Re: 2-ZN-2024
Artessa
Key Code: G0949

Katie: Please see the applicant responses to the 2nd Review Letter dated August 16, 2024.

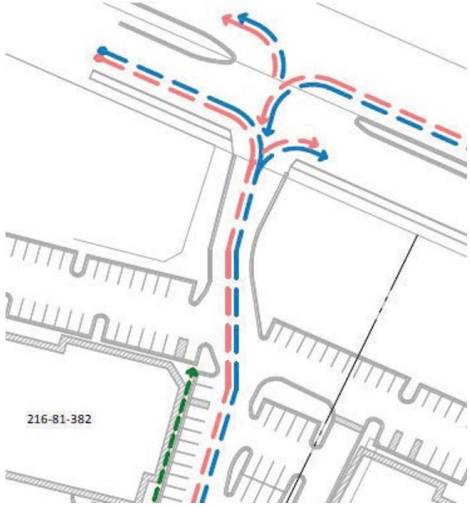
Item	Response
allowed in a required yard or building setback. Please relocate the garages and canopies out of the 80' setback. If parking spaces (without building coverage) are going to remain, please screen with a 3' tall site wall, outside easements.

LOT	FRONTAGE OPEN SPACE	OPEN SPACE OUTSIDE FRONTAGE	COMMERCIAL FLOOR AREA	HOTEL KEYS	RESIDENTIAL UNITS	Lot 1 (Main Retail)	18,740	32,834	40,091	0	0	Lot 2 (Hotel)	0	10,599	0	117	0	Lot 3 (Apts)	14,250	30,732	1,700	0	274	Lot 4 (Corner Retail)	7,392	3,676	5,825	0	0	Totals Provided	40,382	77,841	47,616	117	274	Min/Max Required for Full Property	23,964 min.	71,894 min.	46,920 min.	116 min.	274 max.	<p>Comments have been updated on all plans.</p> <p>Subdivision Plan will be provided along with updated DA. DA comments recently received from the City – resubmittal will be sent/uploaded within the next week.</p>
LOT	FRONTAGE OPEN SPACE	OPEN SPACE OUTSIDE FRONTAGE	COMMERCIAL FLOOR AREA	HOTEL KEYS	RESIDENTIAL UNITS																																						
Lot 1 (Main Retail)	18,740	32,834	40,091	0	0																																						
Lot 2 (Hotel)	0	10,599	0	117	0																																						
Lot 3 (Apts)	14,250	30,732	1,700	0	274																																						
Lot 4 (Corner Retail)	7,392	3,676	5,825	0	0																																						
Totals Provided	40,382	77,841	47,616	117	274																																						
Min/Max Required for Full Property	23,964 min.	71,894 min.	46,920 min.	116 min.	274 max.																																						
<p>6. There shall not be any buildings within the 80’ yard setback along the west and south boundaries. Relocate the garage and carport canopies out of the 80’ southern setback to comply with code. Per Z.O.Sec.9.106.C.3.a - No covered parking shall be</p>	<p>Garages and carports have been removed from building setback and screen wall have been added. Refer to architectural site plan.</p>
